Sub: Diversion of 15.345 ha Protected Forest land for the project of widening & strengthening four lane of Navsari-Gandevi road Km. 36/0 to 54/600 in favour of Executive Engineer, R&B Division in Navsari District of Gujarat.

41st Meeting of Regional Empowered Committee, Bhopal
Dt. 24/12/2019

Agenda 5.

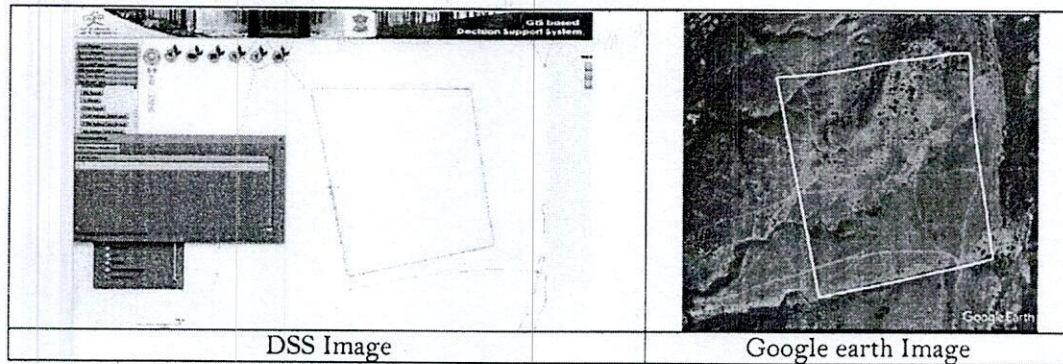
1. The Certificate of Collector under FRA, 2006 for proposed CA land as per Para 6.3e(ii) of Forest Conservation (Rule), 2003 (Amended upto August 2017) shall be submitted.
2. The CA scheme of Model No 2 which is not in accordance to the Para 2.8 (ii) of FCA Handbook 2019. Thus, site specific CA scheme as per the Para 2.8 (iii) of FCA Handbook 2019 is required.

- 1) The CA scheme of Model No 2 on degraded forest land is submitted which is not in accordance to the Para 2.8 (iii) of FCA Handbook 2019. Thus, site specific CA scheme as per the Para 2.8 (iii) of FCA Handbook 2019 and shall also include following points:
 - i. Saplings to be planted (minimum standard height and minimum collar girth species wise).
 - ii. Soil & moisture conservation.
 - iii. Regeneration cleaning.
 - iv. Silvicultural and other activities as prescribed in the working plan.
 - v. Species to be planted (species wise number of plants).
 - vi. Details of proposed monitoring mechanism and outcome parameters
 - vii. Technical & administrative approvals from Competent Authority for current year.
 - viii. The revised CA scheme shall be uploaded on e.portal.
